GRINNELL PUBLIC WORKS OR GROUNDS COMMITTEE REGULAR
SESSION MEETING
MONDAY, OCTOBER 6, 2025, AT 4:45 PM
IN THE COUNCIL CHAMBERS ON THE 2ND FLOOR OF CITY HALL
AND VIA ZOOM
[HTTPS://ZOOM.US/J/97745710963?PWD=AHXLPUWIZRRNOS46BLKA
APDIQZBRXA.1](https://zoom.us/j/97745710963?pwd=AHXLPUWIZRRNOS46BLKAAPDIQZBRXA.1)

A RESOLUTION APPROVING CONTRACT CHANGE ORDER NO. 1 IN THE AMOUNT OF \$88,889.44 FOR A NET INCREASE TO THE CONTRACT WITH WRH, INC. FOR THE WATER TREATMENT PLANT PROJECT.

CONTRACT CHANGE ORDER	Change Order Number:	001	
		MEC Project Number:	2022000116-003	
		Contract Date:	12/2/2024	
For Contracted Project:	Water System Improvements 2023 Water Treatment Plant	Date of Issuance:	10/1/2025	
		Effective Date:		
		Original Contract Price:	\$ 18,990,000.00	
Owner:	City of Grinnell	Current Contract Price:	\$ 18,990,000.00	
Contractor:	WRH, Inc.	Current Contingency Allowance:	\$ -	
		Current Substantial Completion Date:	12/15/2026	
You are hereby requested to comply with the following changes below from the original contracted plans and specifications.				
Description of Changes		ADJUSTMENT to Substantial Completion Date	DECREASE in Contract Price	INCREASE in Contract Price

Photo 3. Approx. Extents Soft Wet Clays near Eastern Wall, Looking Southeast

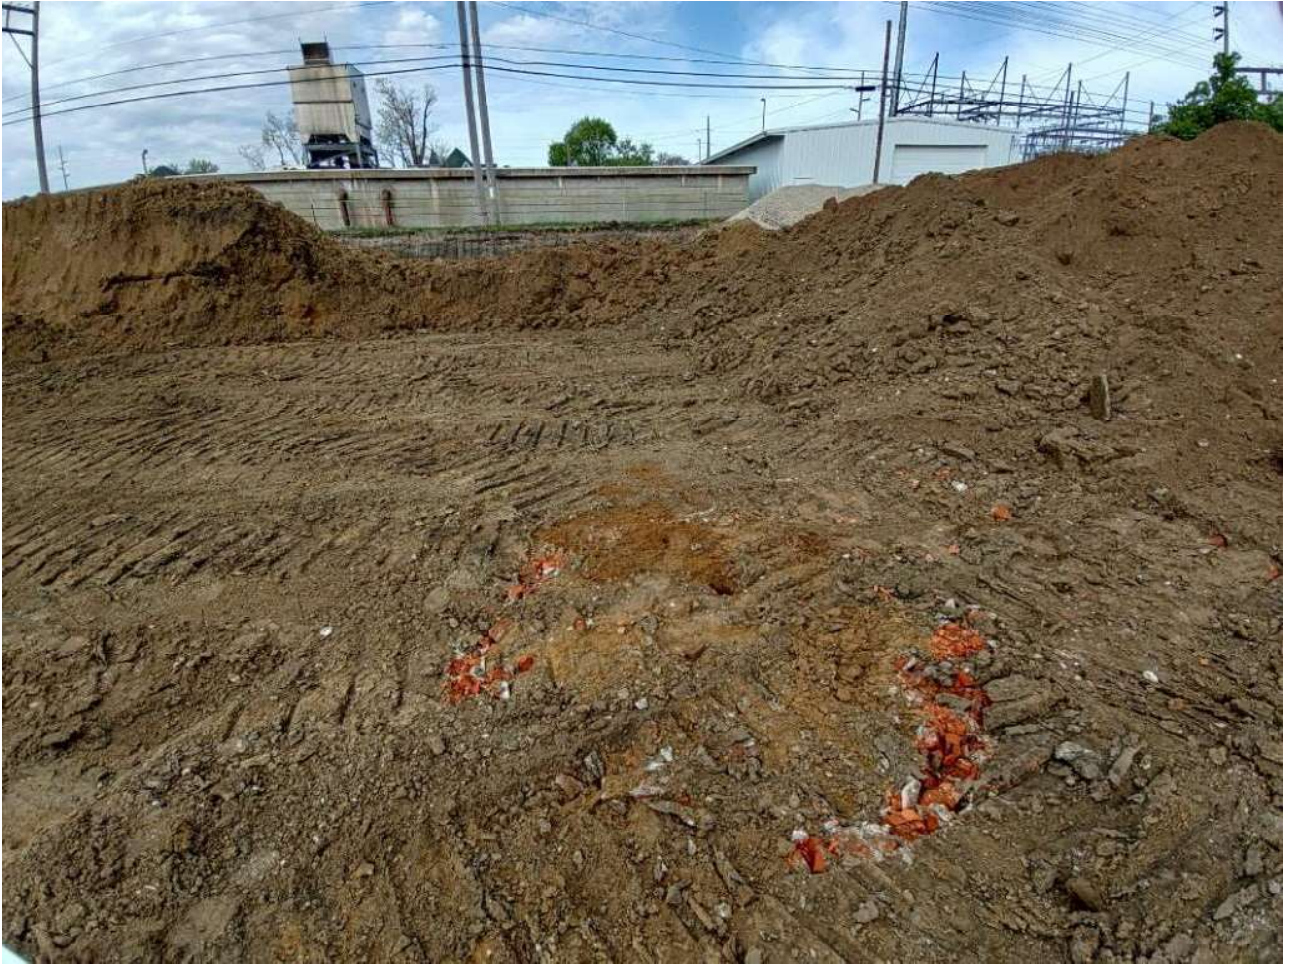
Observed excavation in progress for soil correction beneath the proposed Water Treatment Plant Building. Upon arrival on site, observed existing fill soils were being excavated to elevation 1015 feet based on GPS elevation provided by the excavating contractor, Veith. Excavation for the interior trench in the western portion of the building pad had been completed previously. The attached Excavation Observation sketch shows the observed area outlined in green, and the area is also shown in attached Photo 1. Performed random hand auger borings and visual observations of the exposed excavation bottom soils at elevation 1015 ft.

Excavation Observation Sketch and Sheet WT-C3 Markup

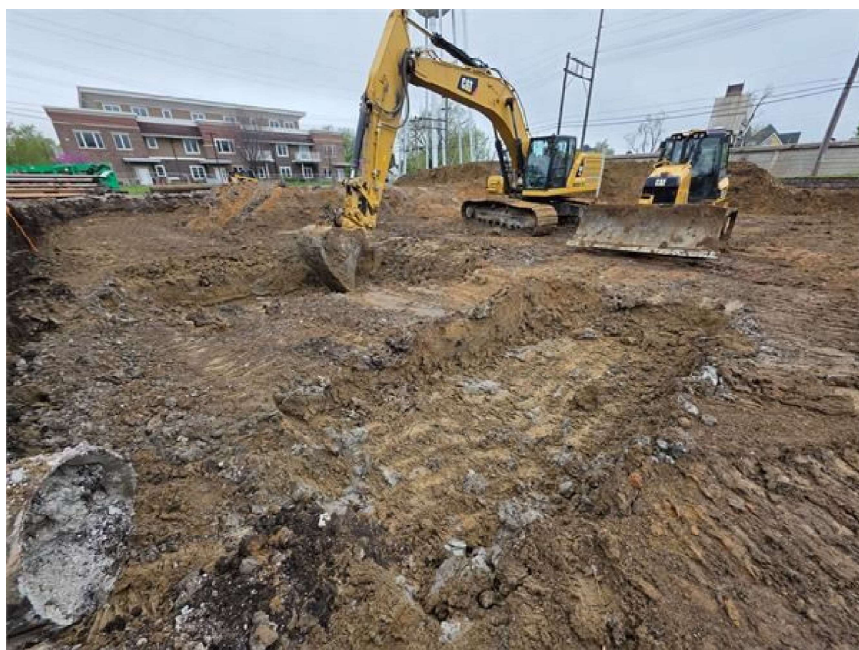
Observed two areas of soft, wet soils observed the previous day (Item C in previous report) were excavated to a suitable subgrade of native lean clay. The attached photos show the areas following removal of the soft soils and following placement and compaction of structural fill to approximately elevation 1015 feet.

Per discussions with Bret Bender, PE, of Braun Intertec, a conference call had been held this morning regarding the observed existing Cisterns (Item A in previous report), with representatives from McClure, WRH, and Veith in attendance. The following recommendations were made to the project team, discussed, and clarified. The attached markup of Sheet WT-C3 also includes a summary of the recommendations for excavation and removal of the northern Cistern.

DRAWING NO. WT-C11 SHEET NO. 35 / 158

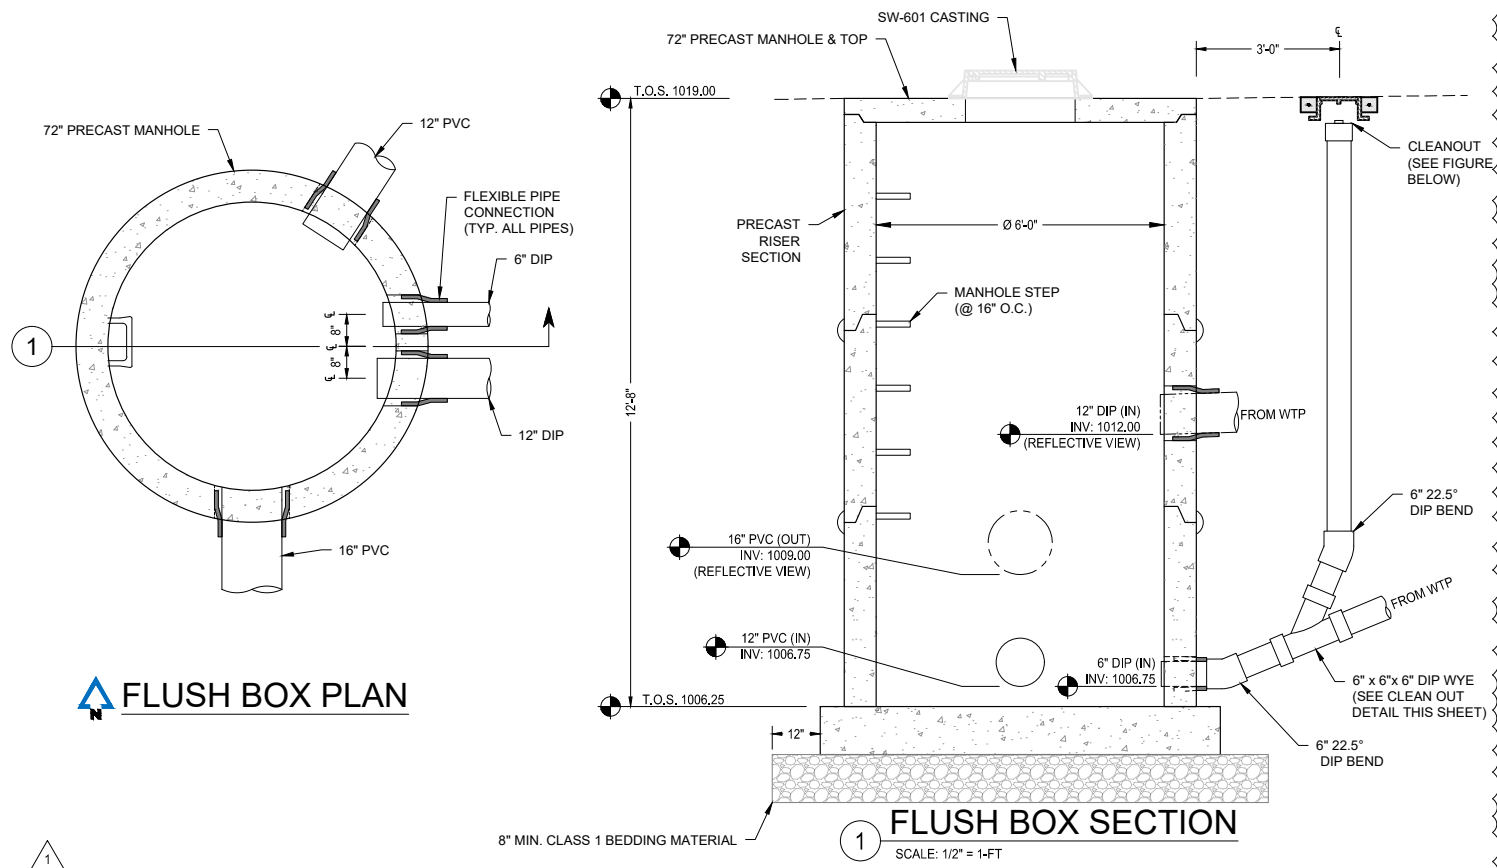
REVISIONS
△ CHANGE ORDER #2 (April)
